## **Proposal for Amendment 3 of the GTR9**

### **Submitted by the Chair (Republic of Korea) of the Informal Working Group on the Deployable Pedestrian Protection Systems of UN Global Technical Regulation No. 9.**

It is to amend the Proposal for Amendment 3 of GTR9 and proposed modifications to the current text of the Working Document ECE/TRANS/WP.29/GRSP/2023/6e are marked in bold for new or strikethrough for deleted characters.

**Fig. 1 (b): Effect of DPPS Deployment on Launching Duration Headform Impactor (Example).**

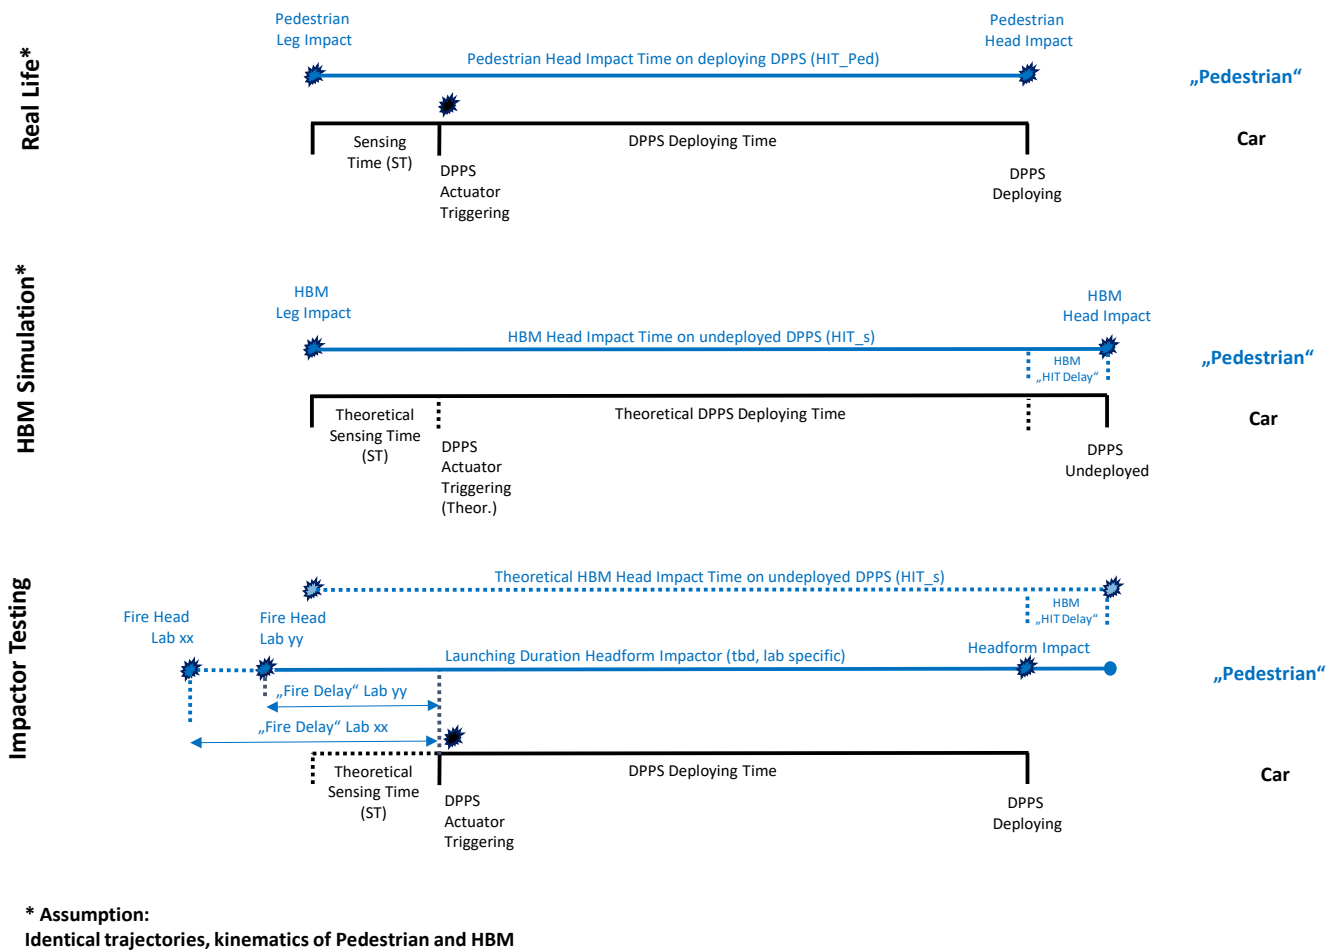
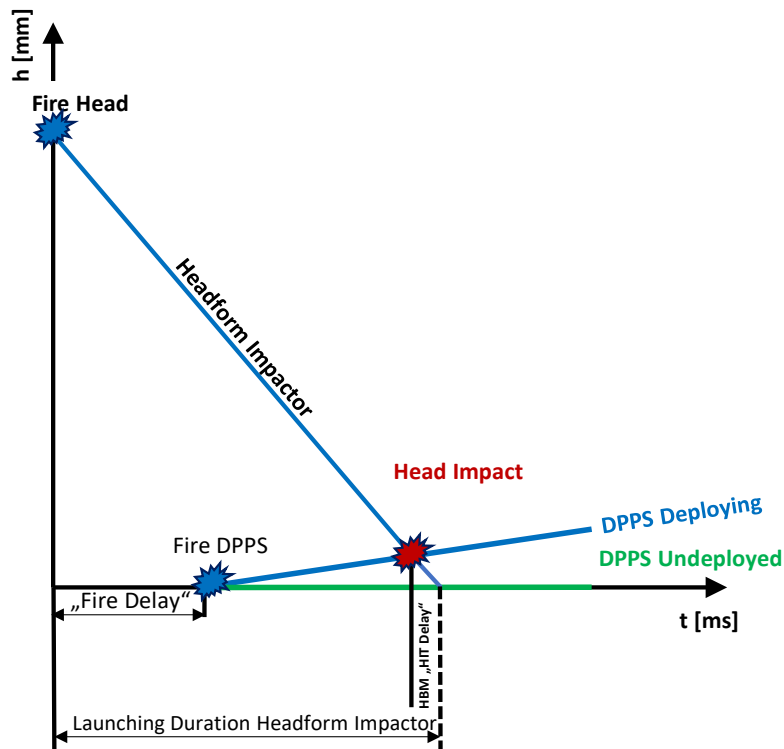
297. For the dynamic test option, the IWG investigated possible misinterpretations of the calculated and actual launching time of the headform impactor during dynamic tests. Since the fire delay between the initiation of the launch of the headform and the triggering of the DPPS actuators is, amongst other things, based on the HIT of the HBM on the undeployed DPPS (HIT<sub>s</sub>), but the actual headform impact takes place on the deploying DPPS (see Fig. 1 (a)), the actual launching duration will deviate from the calculated one, as depicted in Fig 1 (b).

This needs to be taken into account in the course of verification of ambient conditions for dynamic tests.

"Figure 11

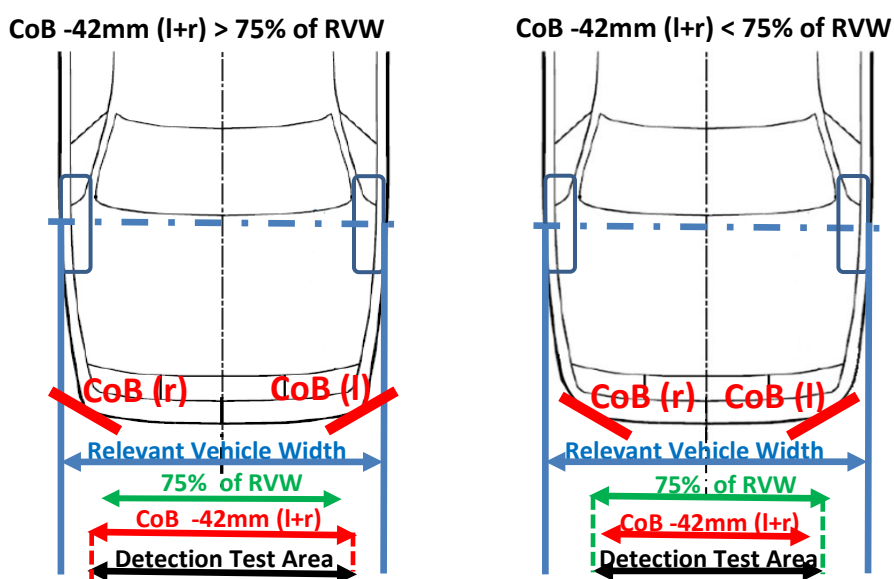
Figure 11, enlarge CoB written spaces, amend to read :

Figure 1-4(a): Synchronization of Test Rig and DPPS Deployment (Example)

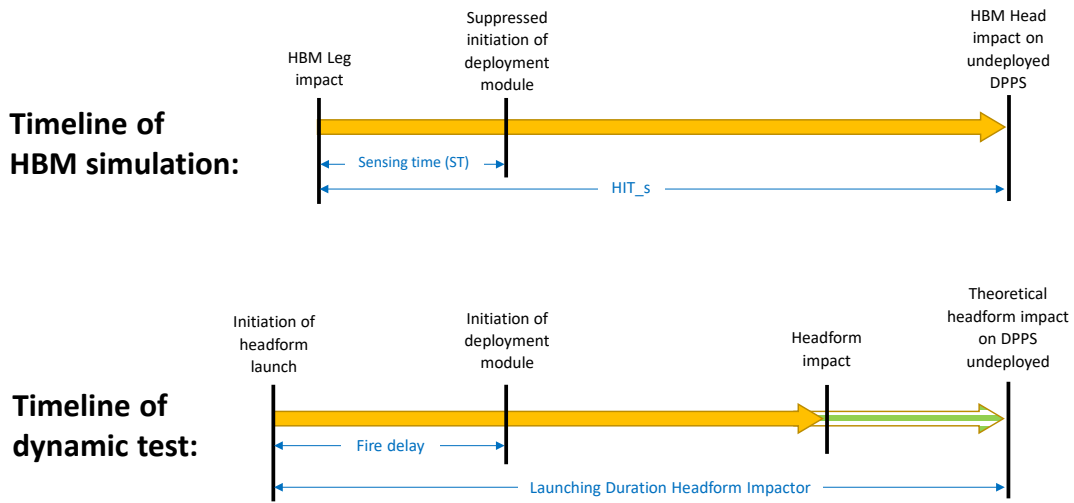
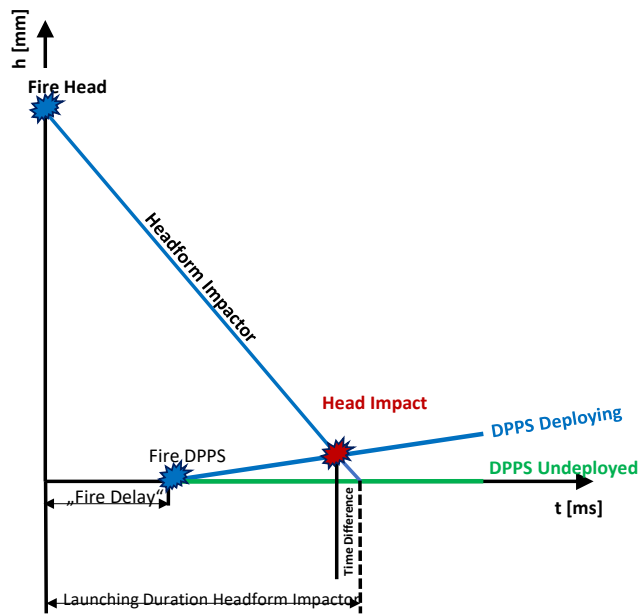
*Paragraph 4.2.1.3., delete former text and figure and amend to read:*

**The test facility shall ensure that the head impact occurs at the correct time relative to the deployment of the DPPS, taking into account the HIT\_s for the corresponding WAD of the head impact point from Figure 1-3 and ST, as shown in the example in Figure 1-4 (a) below.**

**The “Launching Duration Headform Impactor” is rig-specific and is the time period between launching of the headform impactor and the theoretical time of head impact on the undeployed DPPS. Due to the DPPS deployment during testing, the *actual* launching duration of the headform impactor is expected to differ from the launching duration headform impactor (time difference: see example in Figure 1-4 (b)).**

**„Fire Delay“ is the elapsing time between the initiation of the headform launch and the initiation of the DPPS deployment module.**

**It is determined according to the equation:**

***Fire Delay = Launching Duration Headform Impactor – (HIT\_s – ST).***

### Flowchart DPPS Assessment<sup>1</sup>

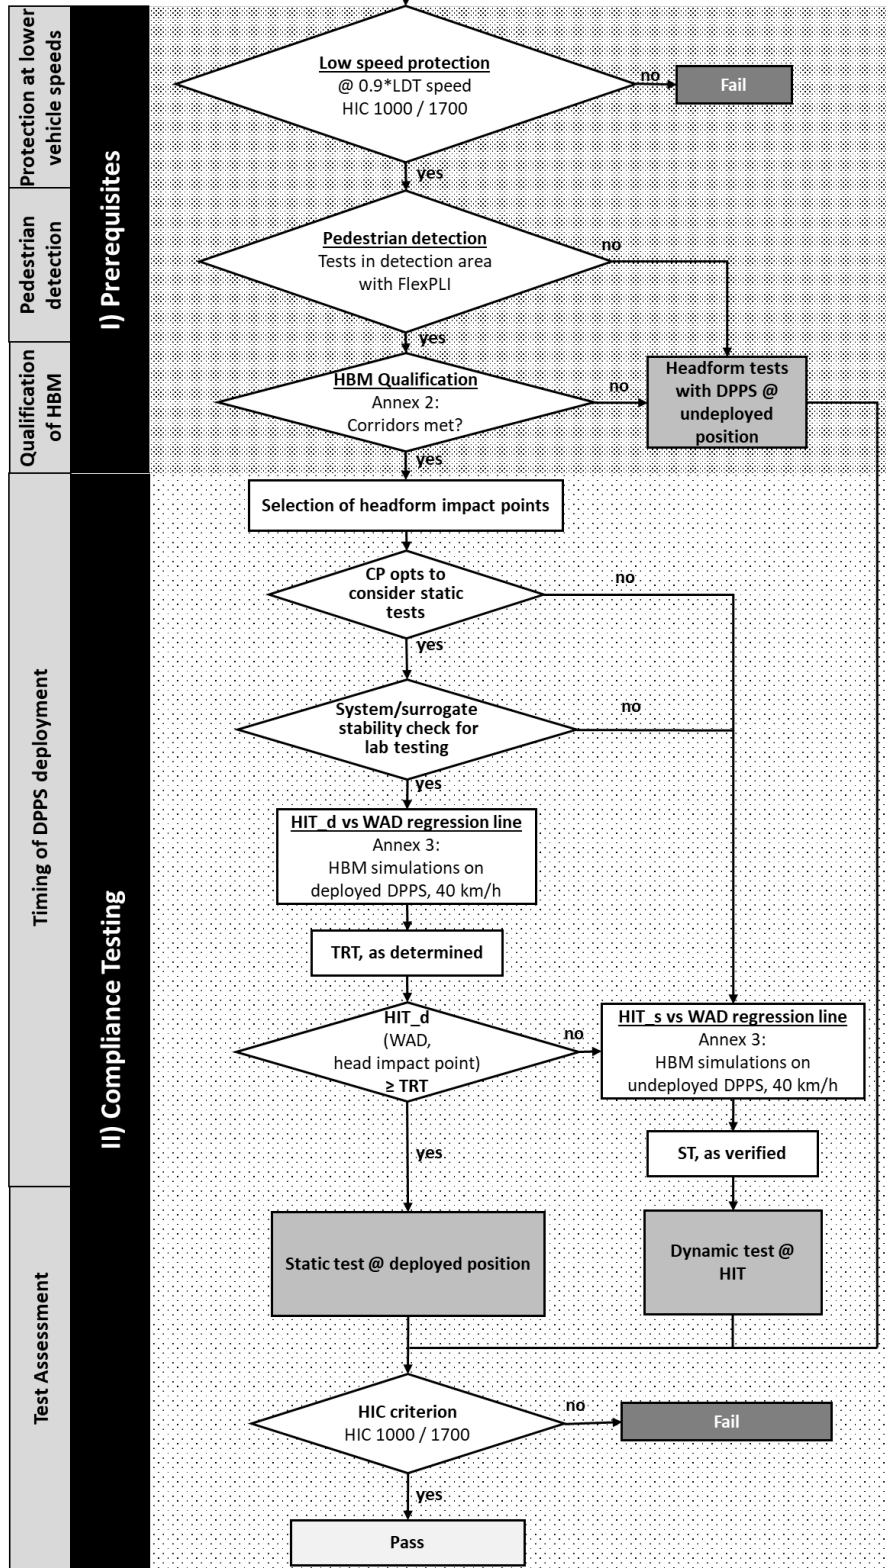
In Annex 1 – Appendix, replace former figure as follows:
